## Product Change Notification / SYST-11TJOJ589

ERRATA - PIC32MX1XX/2XX/5XX 64/100-pin Family Silicon Errata and Data Sheet Clarification

## PIC32MX1XX/2XX/5XX 64/100-pin Family Silicon Errata and Data Sheet Clarification

## 17. Module: I/O Port - Initial Pin State

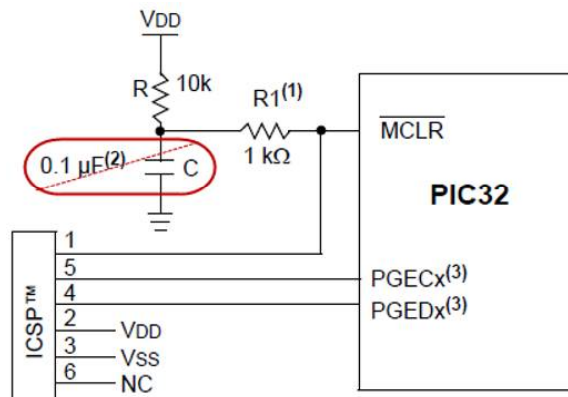
On power-up depending on the VDD ramp rate, the I/O pins can be in an active random output driving state if  $\overline{\text{MCLR}}$  is active until a BOR event.

If, not using an external reset supervisor IC or equivalent, remove the  $\overline{\text{MCLR}}$  capacitor as shown below, and retain the  $\overline{\text{MCLR}}$  Pull-up resistor.

If using an external reset supervisor IC or equivalent, increase the value of the VCAP capacitor to  $\geq 47 \mu\text{f}$  ceramic or solid tantalum capacitor with an ESR  $\leq 1 \text{ ohm}$ .
